CONTRACT CHANGE ORDER NO. _____
SHEET ___ OF ___

MARK	DATE	DESCRIPTIONS	BY	CH'D	CCO#
2	04/08/11	SUSPENSION CABLE MISCELLANEOUS DETAILS	GB	MN	185
1	01/28/11	MISCELLANEOUS CABLE SYSTEM DETAILS	GB	MN	37S1

SAN FRANCISCO OAKLAND BAY BRIDGE
EAST SPAN SEISMIC SAFETY PROJECT
SELF-ANCHORED SUSPENSION BRIDGE
(SUPERSTRUCTURE & TOWER)
EAST CABLE ANCHORAGE "E" LINE LAYOUT NO. 2

EAST CABLE ANCHORAGE DETAILS

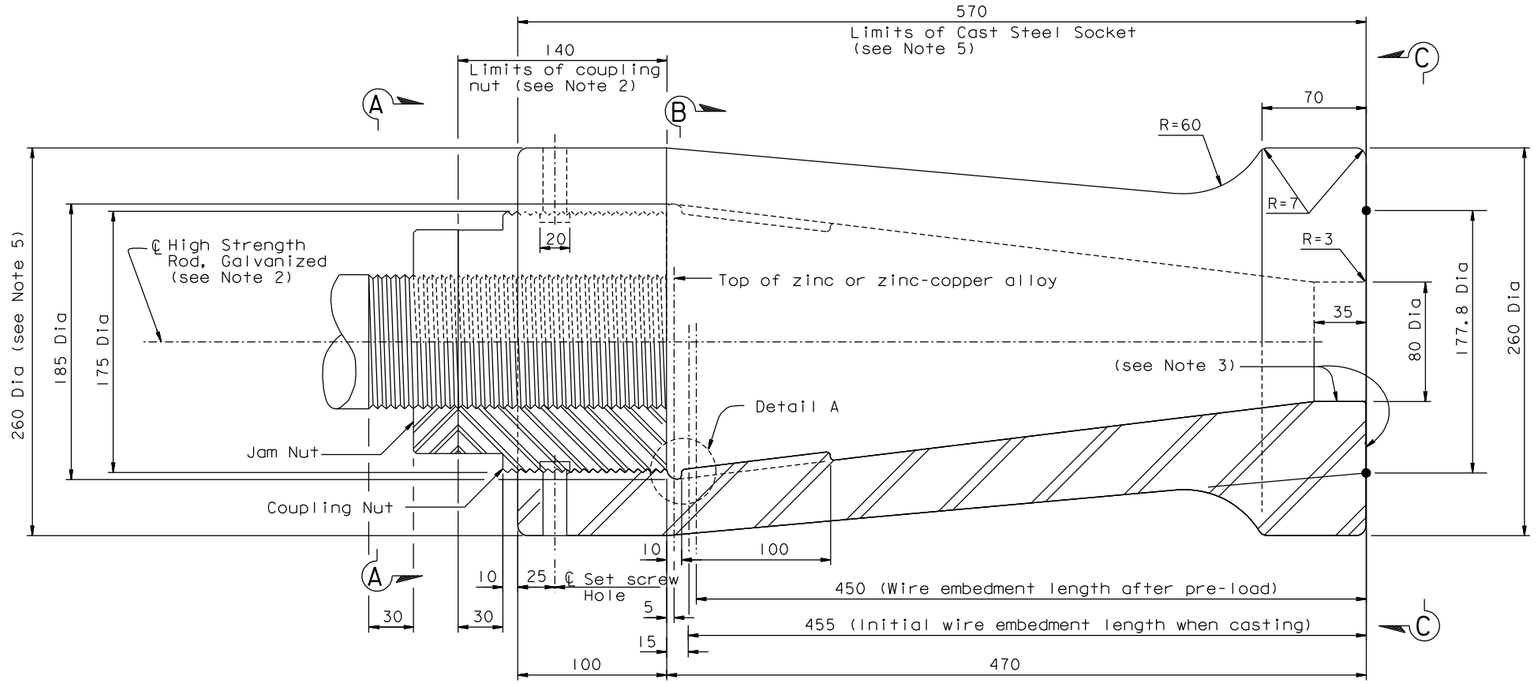
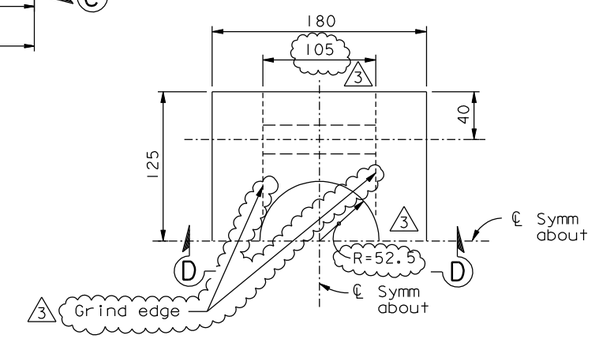
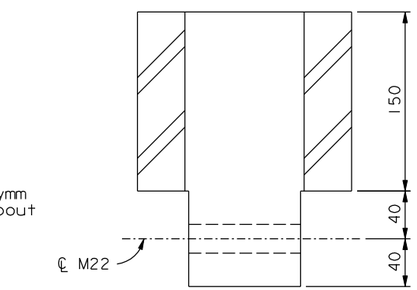
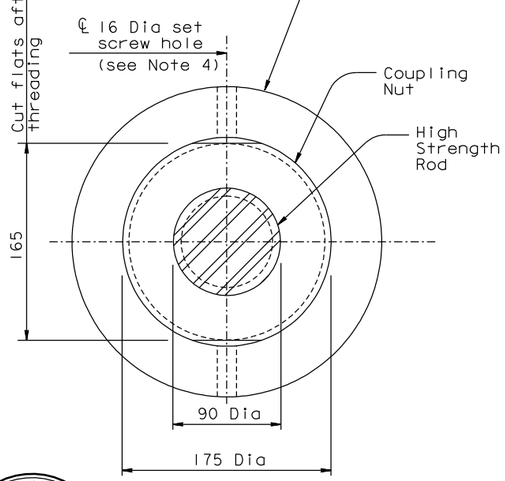
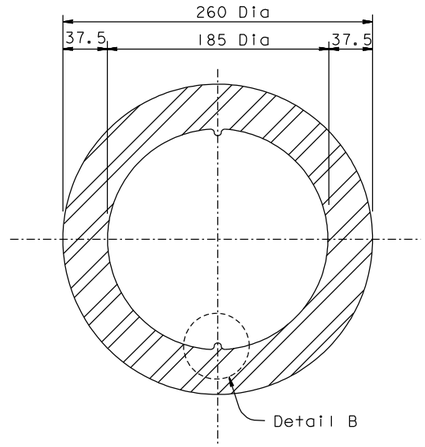
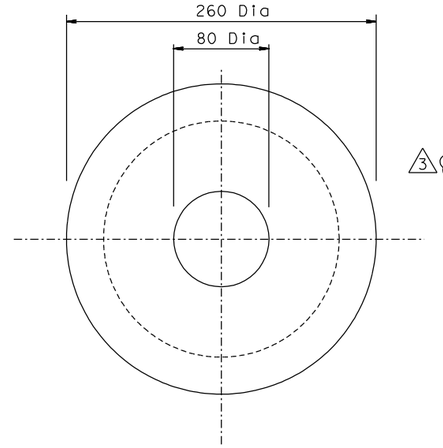
1. Coupling nut and socket shall conform to ASTM A194 GR 7, with 4 threads per inch.
2. For main cable strand anchor rod and cable strand socket materials, see "General Notes" sheets.
3. Surface shall be finished to ANSI 500.
4. Provide 16 Dia stainless set screws in threaded hole.
5. All socket dimensions are for information only. The Contractor shall develop socket details consistent with his means and methods and the east cable anchorage geometry, and shall submit them to the Engineer for review and approval. The socket dimensions shall be such that adequate prestressing and erection clearance is provided.
6. Material for bearing blocks shall be ASTM A668 Grade F, or ASTM A148 Grade 550-345.

MARK	DATE	DESCRIPTIONS	BY	CH'D	CCO#
3	04/08/11	SUSPENSION CABLE MISCELLANEOUS DETAILS	DT	GB	185
2	01/28/11	MISCELLANEOUS CABLE SYSTEM DETAILS	DT	GB	37S1
1	08/28/09	BEARING BLOCKS	DT	GB	78

SUSPENSION CABLE MISCELLANEOUS DETAILS NO. 1

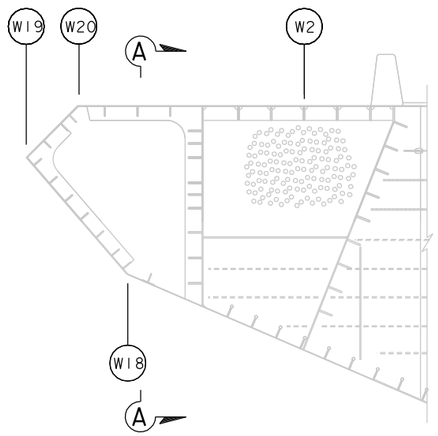
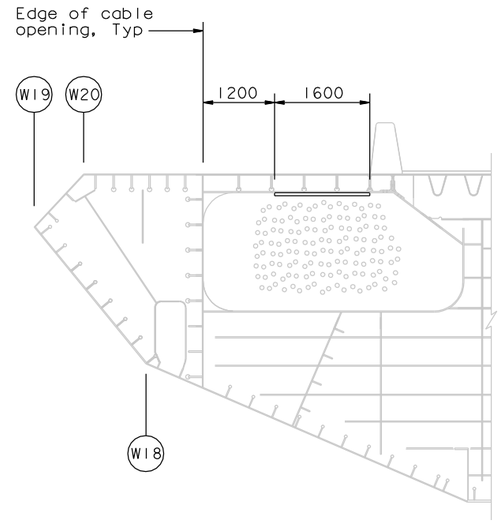
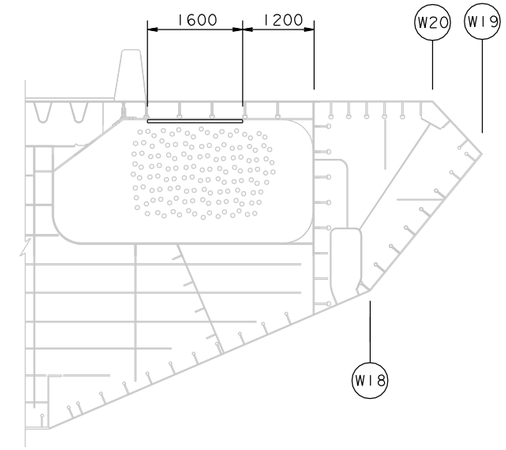
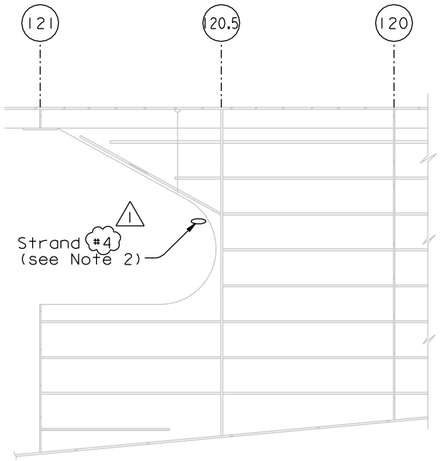
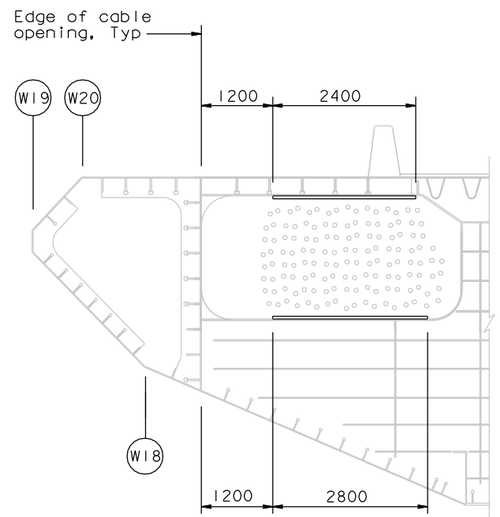
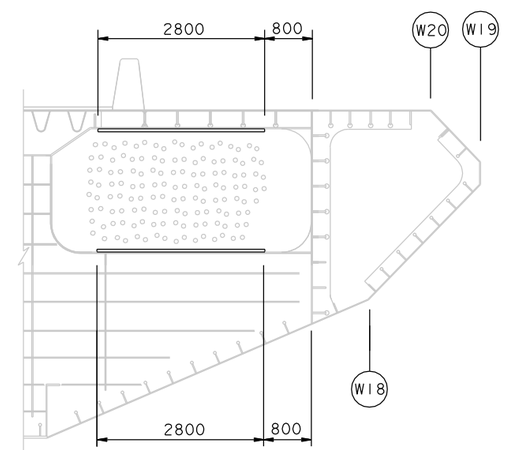
1. For details of neoprene pad at cable opening flanges, see "Suspension Cable Miscellaneous Details No. 6" sheet.
2. Strand #4 (1) shall be wrapped in the vicinity of the K plate per the "PWS Strand Sheathing" detail on "Suspension Cable Miscellaneous Details No. 4" sheet.

MARK	DATE	DESCRIPTIONS	BY	CH'D	CCO#
1	02/24/12	SUSPENSION CABLE MISCELLANEOUS DETAILS	MN	GB	185
0	02/08/11	SUSPENSION CABLE MISCELLANEOUS DETAILS	MN	GB	185

SUSPENSION CABLE MISCELLANEOUS DETAILS NO.2

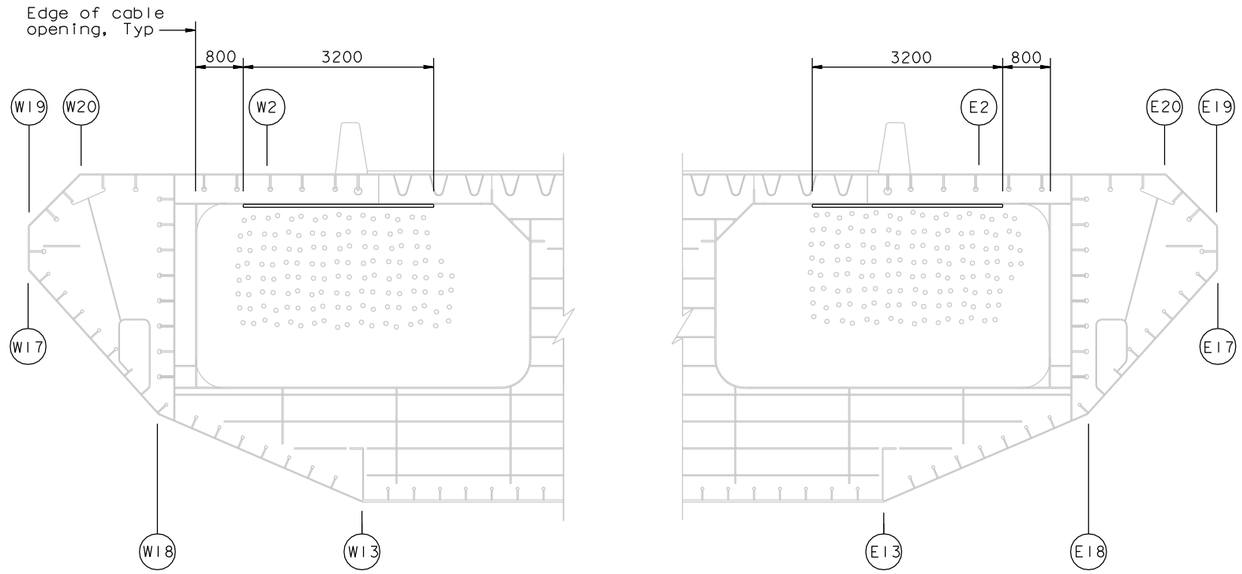
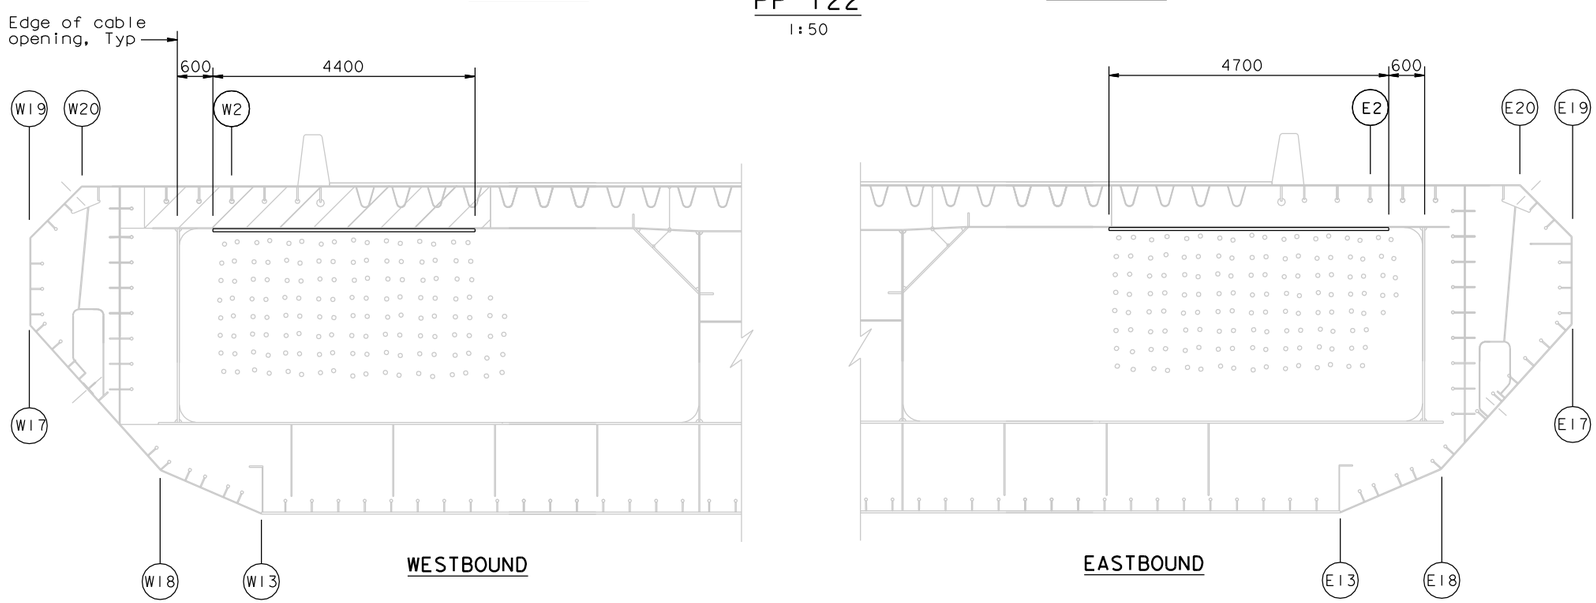
1. For details of neoprene pad at cable opening flanges, see "Suspension Cable Miscellaneous Details No.6" sheet.
2. Protection for PWS strands is not required at PP 122.5 (EB & WB).

MARK	DATE	DESCRIPTIONS	BY	CH'D	CCO#
0	02/08/11	SUSPENSION CABLE MISCELLANEOUS DETAILS	MN	GB	185

SUSPENSION CABLE MISCELLANEOUS DETAILS NO.3

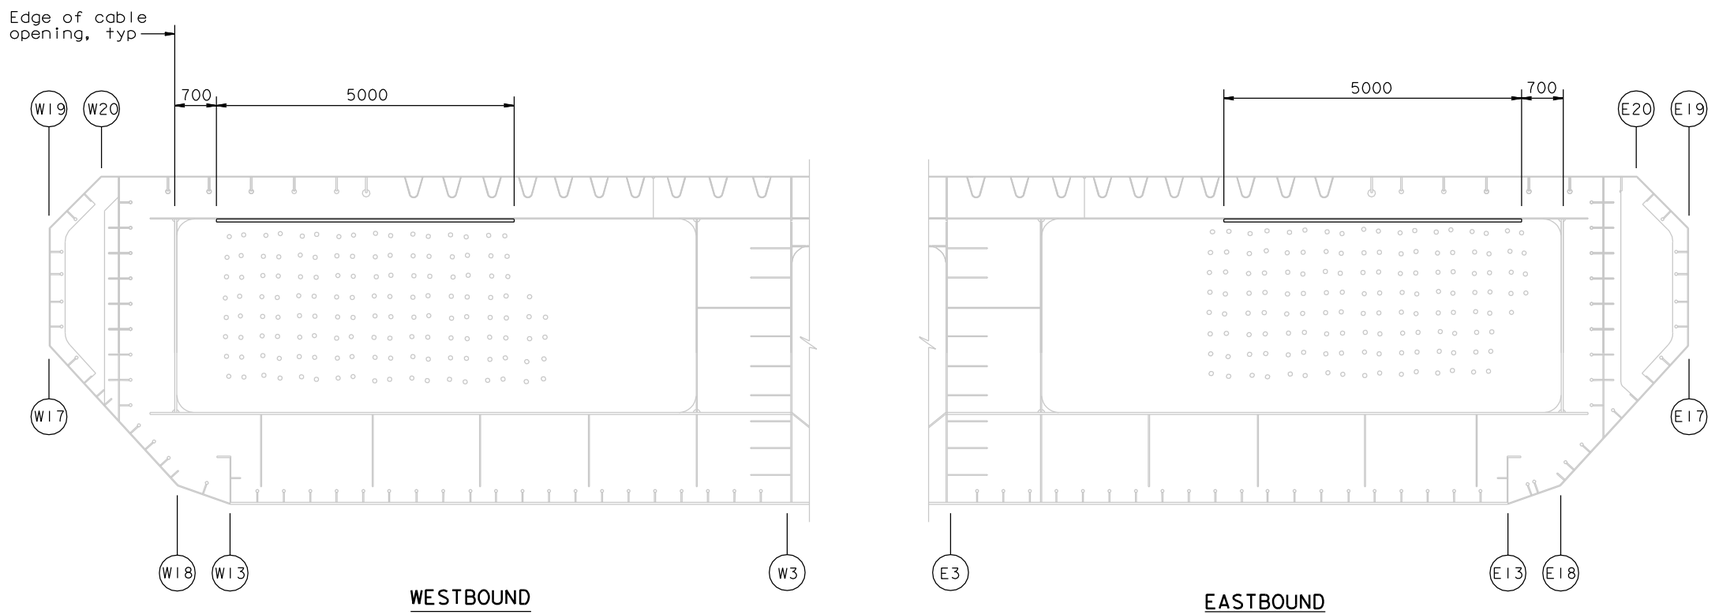
1. For details of neoprene pad at cable opening flanges, see "Suspension Cable Miscellaneous Details No.6" sheet.
2. Protection for PWS strands is not required at PPs 124 & 124.5 (EB & WB).

MARK	DATE	DESCRIPTIONS	BY	CH'D	CCO#
0	02/08/11	SUSPENSION CABLE MISCELLANEOUS DETAILS	MN	GB	185

SUSPENSION CABLE MISCELLANEOUS DETAILS NO. 4

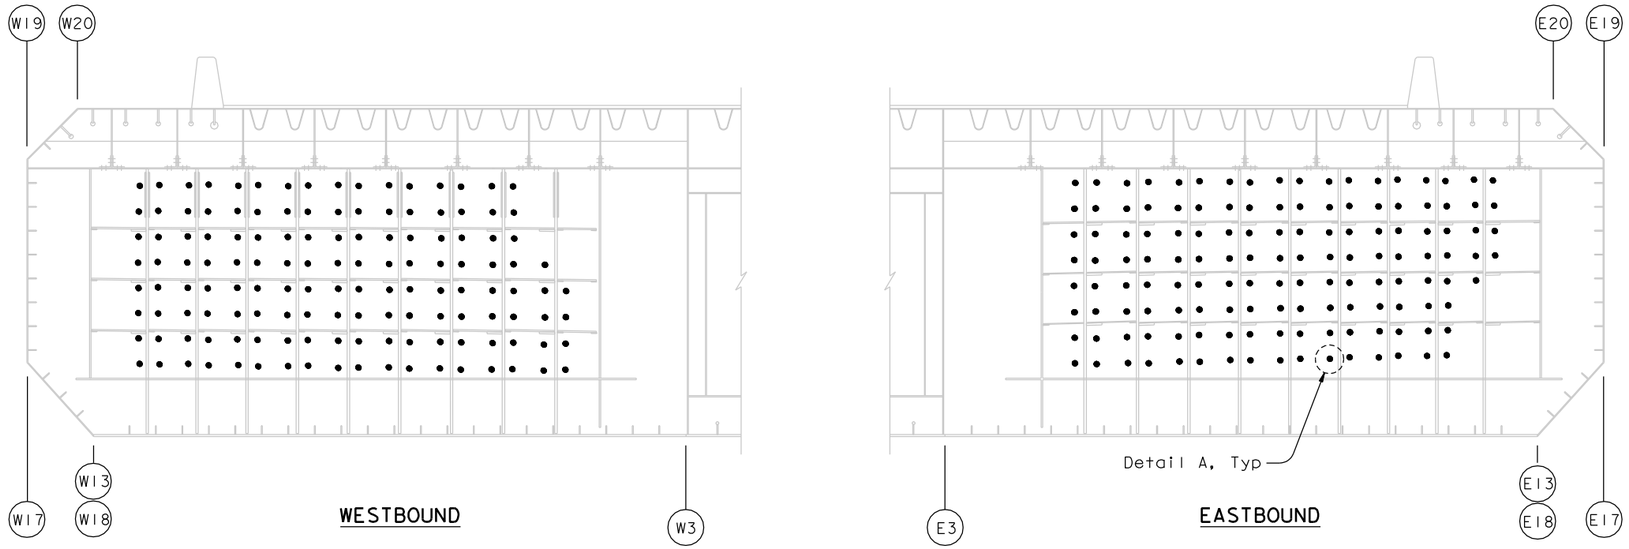
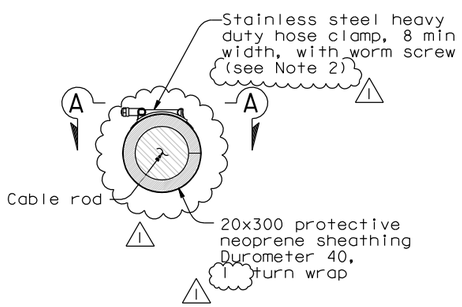
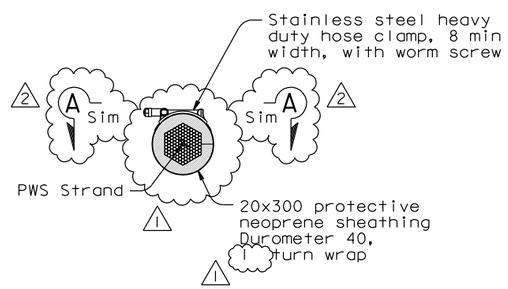
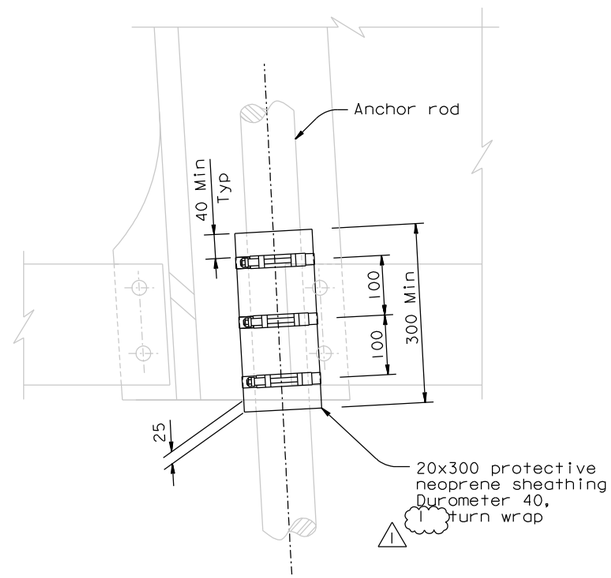
1. The Contractor shall provide twenty spare protective neoprene sheathing wraps to be installed as directed by the Engineer.
2. The worm screw shall be oriented so as to avoid nearest obstructions.
3. For PWS Strand Sheathing, the center hose clamp may be omitted.

MARK	DATE	DESCRIPTIONS	BY	CH'D	CCO#
2	02/24/12	SUSPENSION CABLE MISCELLANEOUS DETAILS	MN	GB	185
1	12/22/11	SUSPENSION CABLE MISCELLANEOUS DETAILS	MN	GB	185
0	03/25/11	SUSPENSION CABLE MISCELLANEOUS DETAILS	MN	GB	185

SUSPENSION CABLE MISCELLANEOUS DETAILS NO.5

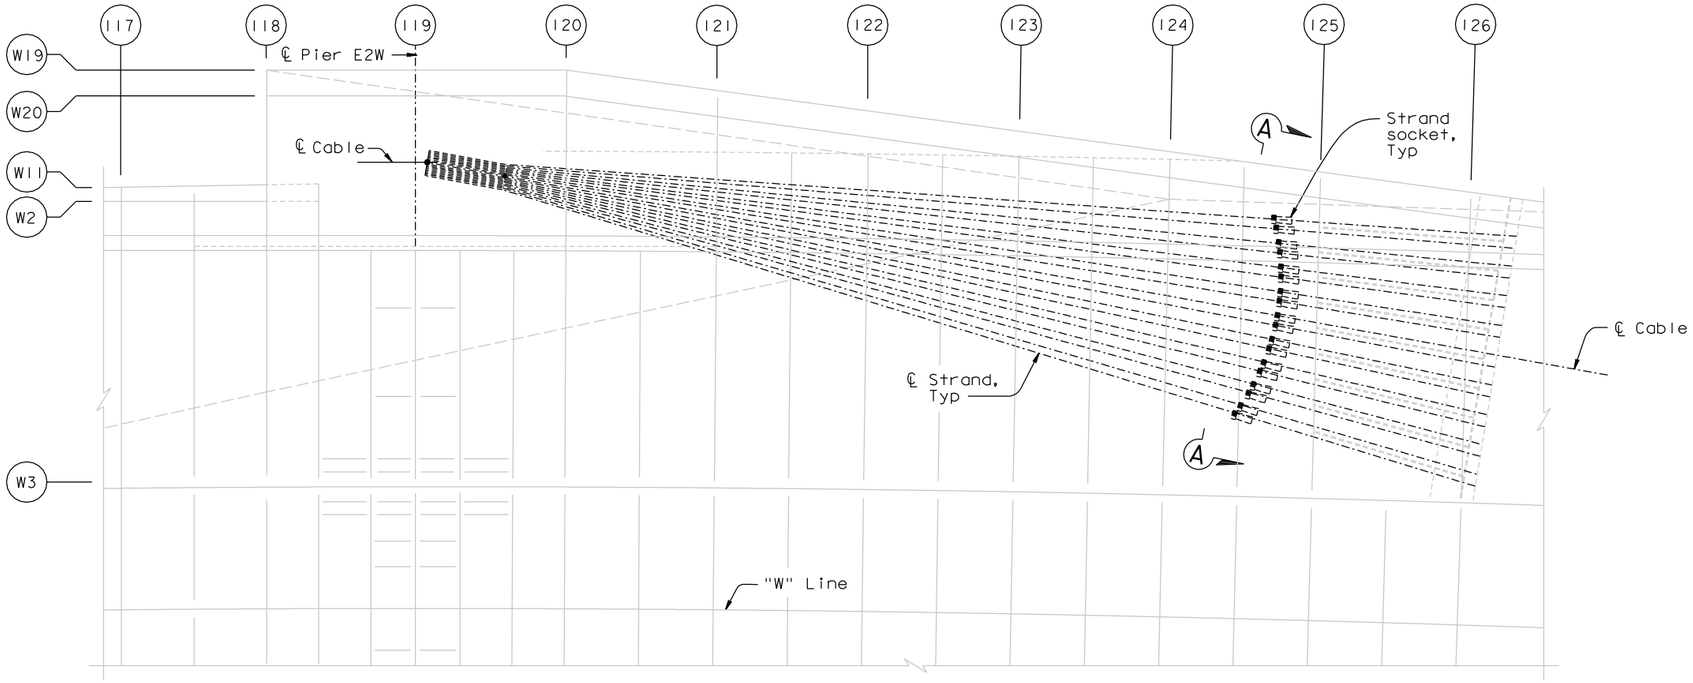
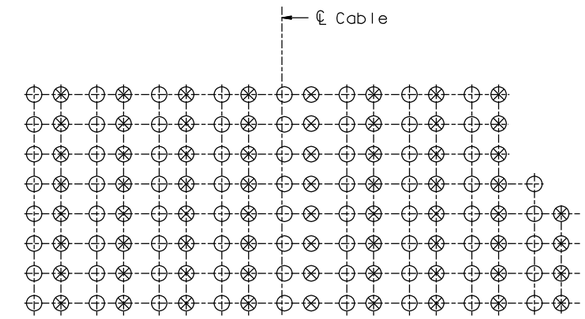
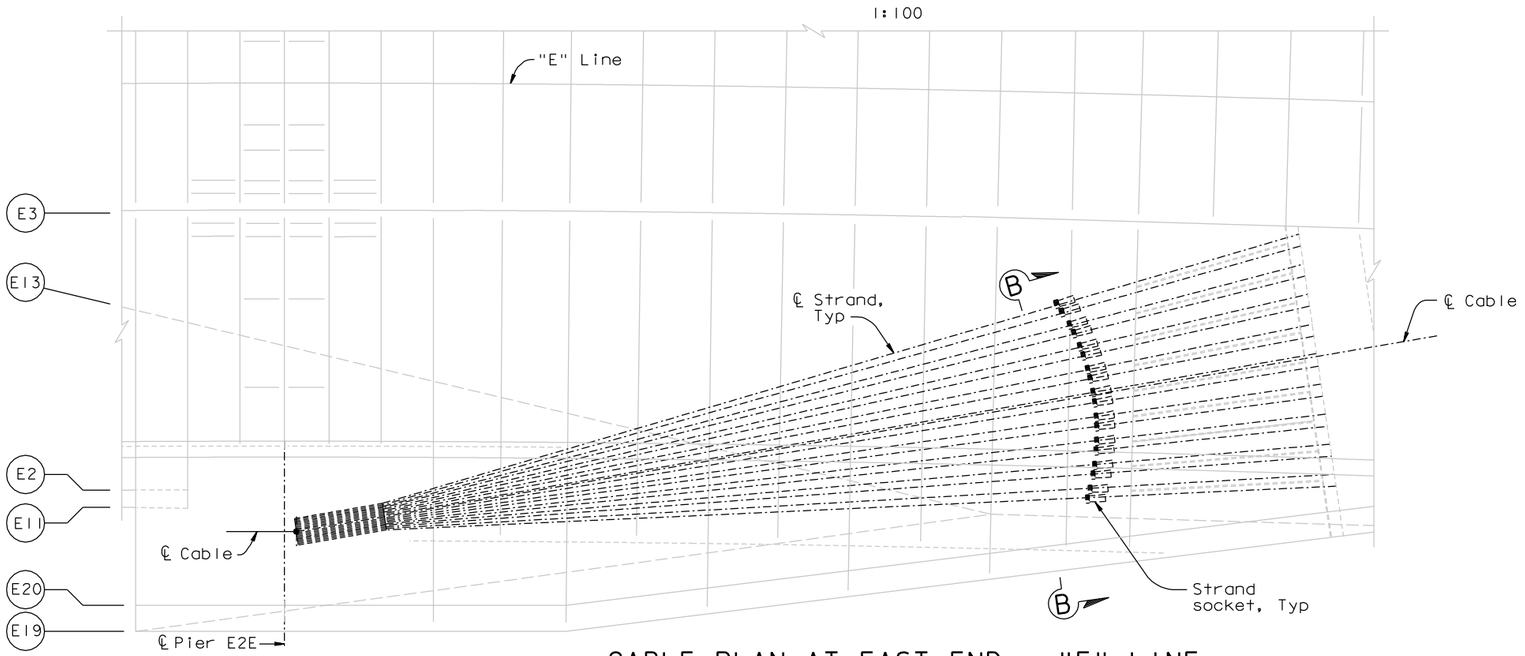
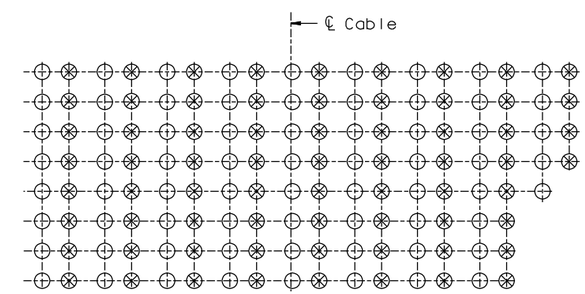
1. For neoprene wrap details, see "Suspension Cable Miscellaneous Details No.6" sheet.

MARK	DATE	DESCRIPTIONS	BY	CH'D	CCO#
0	02/08/11	SUSPENSION CABLE MISCELLANEOUS DETAILS	MN	GB	185
